Gladstone Treatment Plant TBA - Phase II FSP
Signature Page
Revision: 0
Date: 07/2005
Page 1 of 4

PHASE II FIELD SAMPLING PLAN**GLADSTONE TREATMENT PLANT**
San Juan County, Colorado

draft Gladstone SAP

FIGURE 1: Site and Sample Location Map

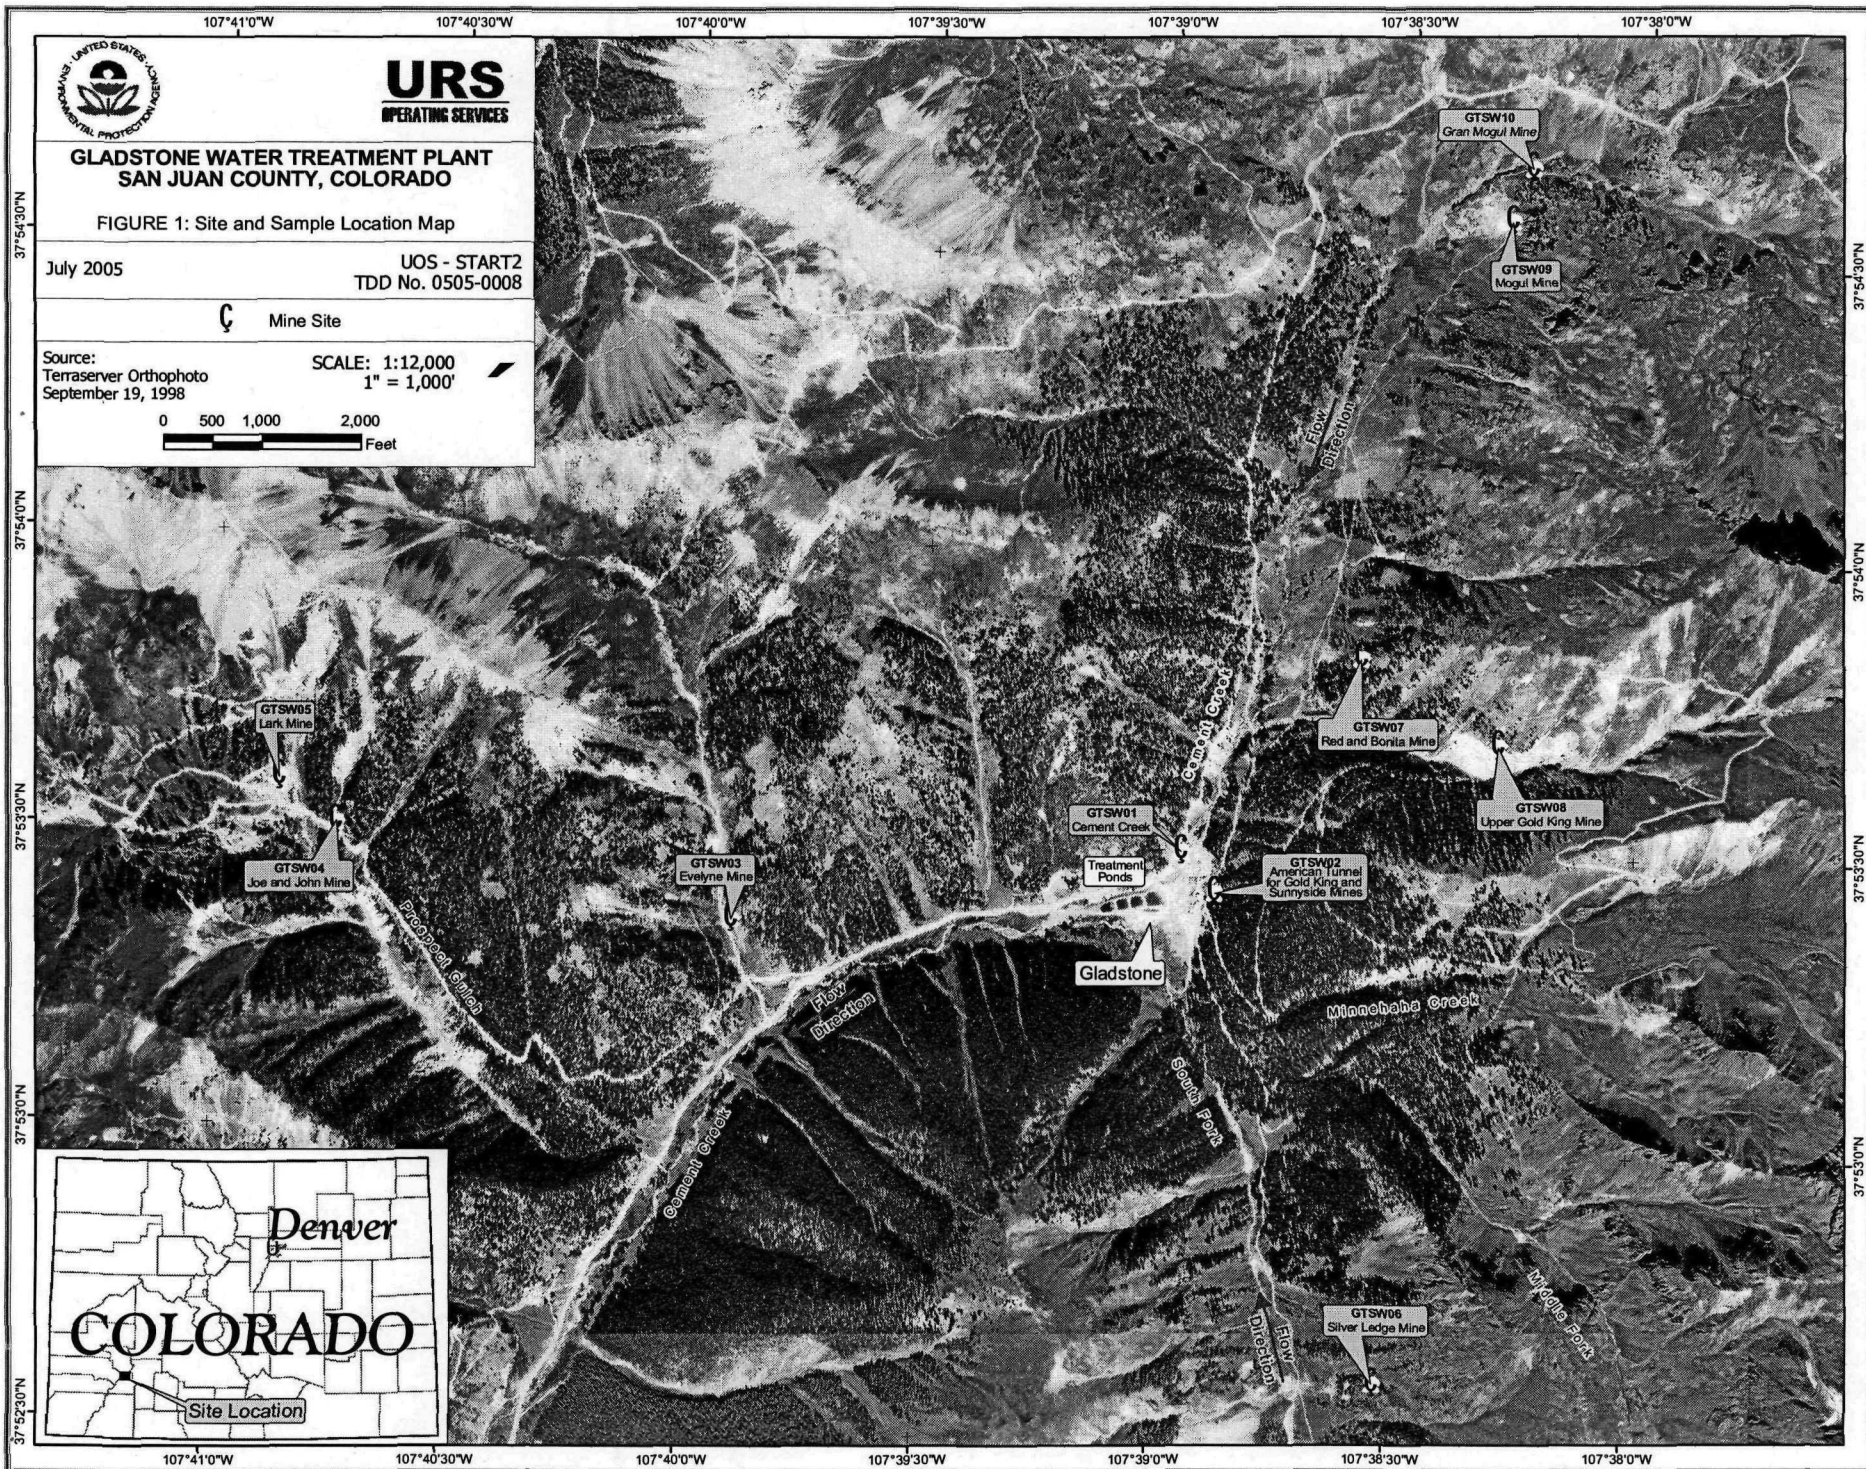
Figure&Table 1 and Sample Locations. Please be aware that the load from an adit is not necessarily equal to the total load from that particular mine. Often the adit discharge represents most of the problem, but sometimes the adit is relatively benign and it is infiltration and runoff from the waste dump or tailing pile that delivers the greatest contribution of metal contaminants. So sometimes we need to focus on the adit and other times it may be more appropriate to look at a reach of impacted stream with diffuse inflows and loads.

My next set of comments addresses your proposed sampling locations with this in mind.

a. Prospect Gulch. Both the Lark and the Joe and John adit openings have undergone gating and some remediation and thus it is the waste dump and

tailings piles that are now probably the greatest ongoing sources of contamination. Sampling the two adits will not accurately represent their load to the subbasin. And we shouldn't forget the Henrietta levels 7&8 and level 10 sites. Owing to the recent remediation activities, this reach is in recovery and it is hard to predict at the moment whether it is getting better or worse. All of the various mine-impacted inflows are quite small and diffuse. I think it would be more effective to treat the combined impacts of this complex as an impacted stream segment. I would sample the main stream just below tributary TR100 and just above TR700 (see Wirt and others, 2001, <http://pubs.usgs.gov/of/2001/ofr-01-0258/>). The stream is fairly small through here (usually on the order of .5 to 1 cfs at low flow) and it might be feasible to treat the entire impacted reach upstream from other larger inflows that come in near the bottom. The tracer reports are very helpful in terms of determining where the biggest loads are, and what kinds of stream discharges to expect.

b. Gold King and North Fork. Once again, the entire reach down from the Gold King is impacted. The adit is large and nasty, the tailing pile is large and steep, and there is a potential that the mine pool could be leaking through to the streambed. More work is needed here to assess flowpaths. I would sample the Gold King adit here, but I would also collect samples bracketing the North Fork abv the GK and abv the mouth.

c. Silver Ledge (or Occidental) and South Fork. I would also sample the Big Colorado because if it is feasible to treat the Occidental it might be simple to collect the adit discharge for the Big Colorado, too. I see it as potentially low hanging fruit. I don't think we need to sample the South Fork because both adit discharges are fairly discrete and are probably the major sources of contamination for each of their respective settings. Treating some of the South Fork adit flows may also help to buffer some of the lower pH adit flows in upper Cement.

d. Another mine in the vicinity that might be worth including is the Mammoth mine on the Georgia Gulch fan near the Upper Bog on Cement Creek. I believe it is Todd Hennessy property so I'd run this idea by Bill and Sabrina, or the Mikes, first.

Who did access on this?
e. Red and Bonita. I'm not sure whether you should sample the adit up top near the opening or at the base of the waste pile at the road culvert. It depends on your objectives. Diverting higher might help to dry out the pile. Diverting at the base might capture more of the impact. Again, more work is needed to better assess the degree of infiltration through the waste dump. Your call. Talk with Ray Johnson about where he collected his samples.

f. Mogul and Grand Mogul. I have not been to these recently, but similar logic applies. I think these flows are fairly discrete and will not be a problem, but if flow is diffuse it will need to be diverted to a single drainage before it is transported for treatment.

g. Cement Creek nr Gladstone abv SF, Eveline, and American Tunnel. No obvious complications and no comments.
